Technical Report			
TRIM Number:	PA19/771	Synergy Number:	PA19/771
Lodgement Date:	31/07/2019	DAU Date:	
Address:	Lot 77, 67 Dalray Court, Darling Downs		
Proposal:	Dwelling, Outbuilding and Two Water Tanks		
Land Use:	‘Residential – Single House’	Permissibility:	Permitted
Owner:	Istvan and Larrine Stempin		
Applicant:	As above		
Zoning:	‘Rural Living A’	Density Code:	R2
Delegation Type:	11.1.1 and 12.1.1	Officer:	Ryan Fleming
Site Inspection:		Yes – 03/10/2019	
Advertising:		Yes – From 05/08/2019 – 26/08/2019	
Outstanding Internal Referrals:		No	
External Referrals:		No	
Within a Bushfire Prone Area:		Yes	
Dwelling – BAL Assessment received Outbuilding – Part 10A, Cl. 78B of the Planning and Development (Local Planning Schemes) Regulations 2015 exempts the requirement for a BAL assessment.

A planning application has been received on 31 July 2019 for proposed dwelling, outbuilding and two water tanks at Lot 77, 67 Dalray Court, Darling Downs.

Figure 1: Recommendation for amended building envelope

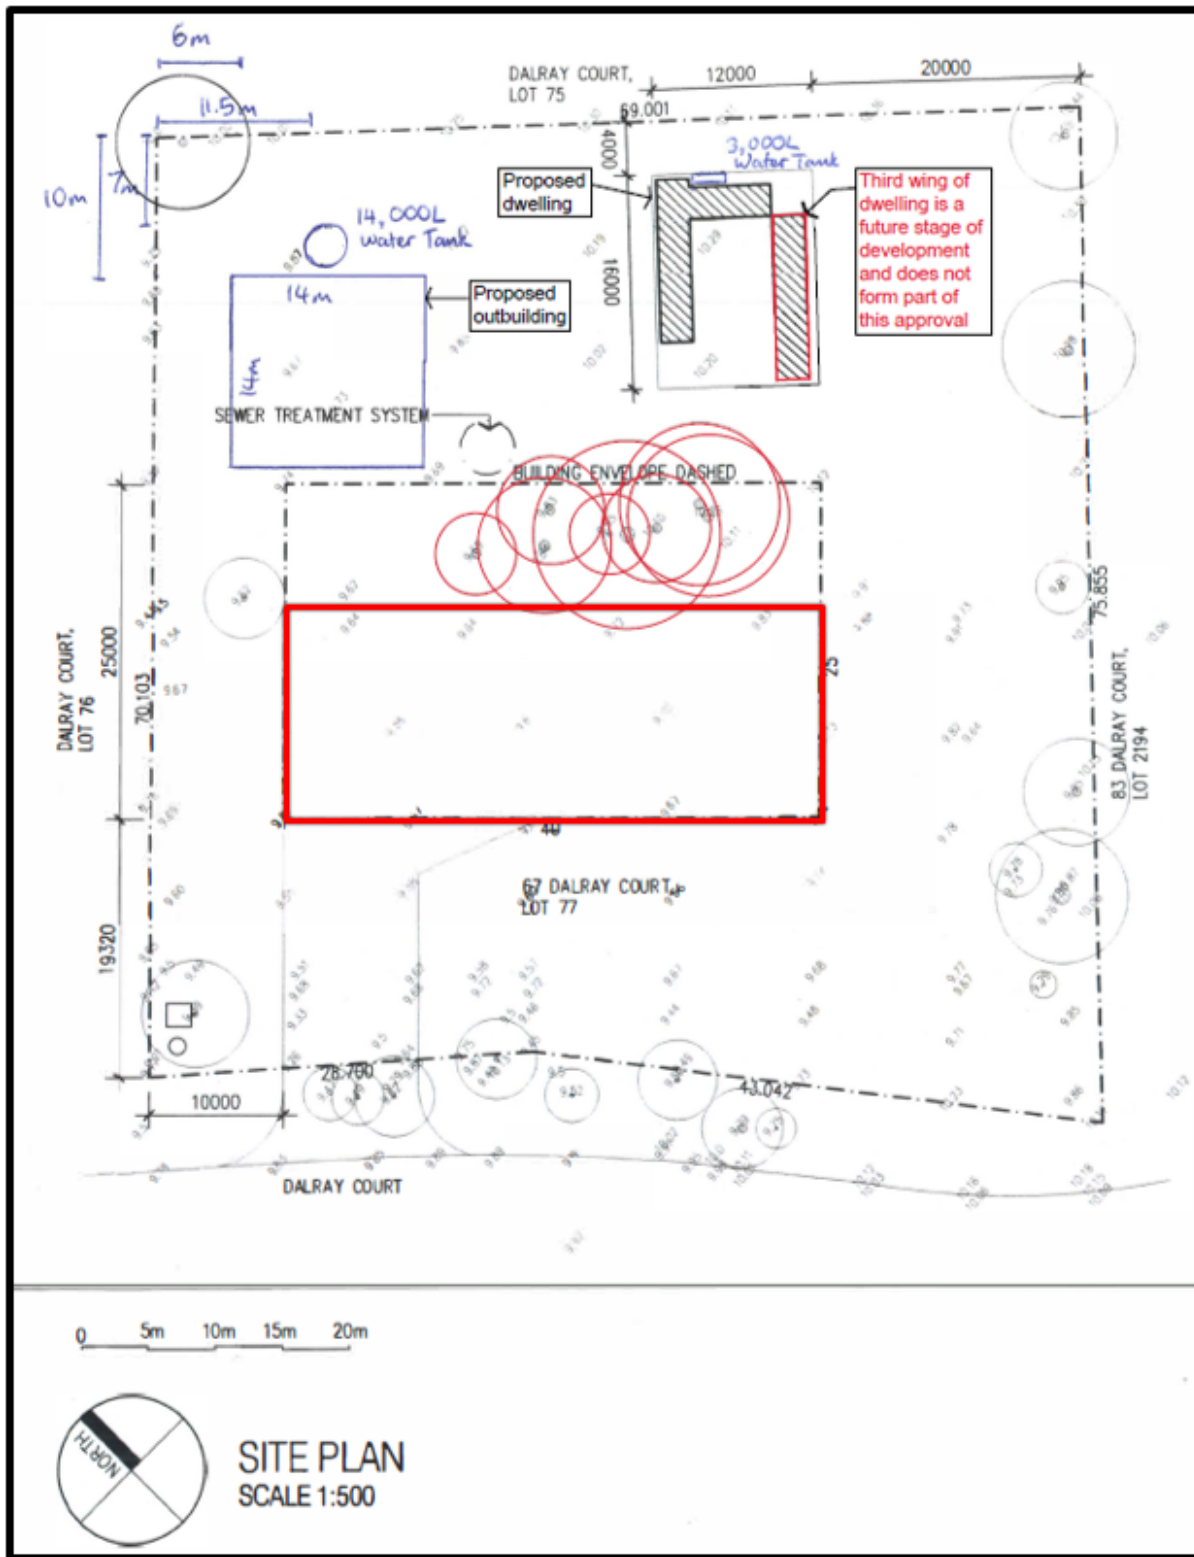
It is noted that there are several mature trees located towards the rear of the building envelope currently. These are the only mature vegetation on the property. Construction of the proposal outside of the building envelope would allow for the retention of these trees. In this case and in light of the retention of the trees, the construction of development outside of the building envelope is supported.

However to ensure the long term protection of these trees, it is appropriate to condition protection of these trees, notwithstanding their location within the building envelope. This is shown following:
